# Access Compliance Report

## Public Rights-of-Way

### (Curb Ramps)

Intersection ID: 13197	Main Street: S_MCDOWELL_ST	Cross Street: E_4TH_ST	Location: W
ADA ID: 05F7E02E4699	Ramp Type: Perp	Initial Pass/Fail: Fail	Overall Compliance: No
Severity Score: 13.75			
Codes/Mitigation Info/Possible Solution		Field Measurements/Component Compliance

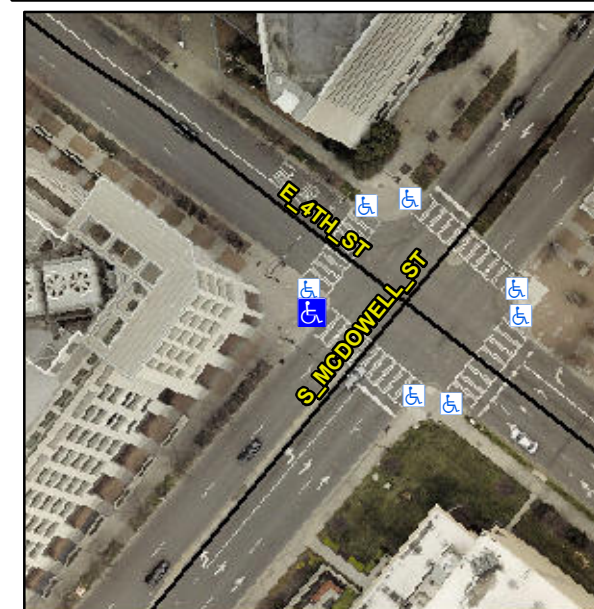
**Not Found, R304.2.2, R304.5.3**

Compliance	Description	Data	Compliance	Description	Data
N/A	Ramp Length (in)	60.0	No	Ramp Slope (%)	11.1
Yes	Ramp Width (in)	49.0	No	Ramp XSlope (%)	2.3
N/A	Flare Type LT	N/A	N/A	Flare Type RT	N/A
N/A	Flare Slope LT (%)	N/A	N/A	Flare Slope RT (%)	N/A
N/A	Flare Traversable LT?	N/A	N/A	Flare Traversable RT?	N/A
N/A	Landing Length (in)	N/A	N/A	DWS Provided?	N/A
N/A	Landing Width (in)	N/A	N/A	DWS Contrast?	N/A
N/A	Landing Slope (%)	N/A	N/A	DWS Length (in)	N/A
N/A	Landing X Slope (%)	N/A	N/A	DWS Full Width?	N/A
N/A	Landing Curb? (Y/N)	N/A	N/A	DWS Offset (in)	N/A
N/A	Shared Landing?	N/A			
N/A	Gutter Ponding?	N/A	N/A	Gutter Slope (%)	N/A
N/A	Gutter Lip Ht (in)	N/A	N/A	Gutter X Slope (%)	N/A
N/A	Painted X Walk1?	Yes	N/A	Painted X Walk2?	N/A
	X Walk 1 Direction	To SE		X Walk 2 Direction	N/A
N/A	X Walk 1 Width (in)	187.0	N/A	X Walk 2 Width (in)	N/A
	X Walk 1 Slope (%)	0.3		X Walk 2 Slope (%)	N/A
	X Walk 1 X Slope (%)	1.6		X Walk 2 X Slope (%)	N/A

**Remove & Replace Entire Ramp.**
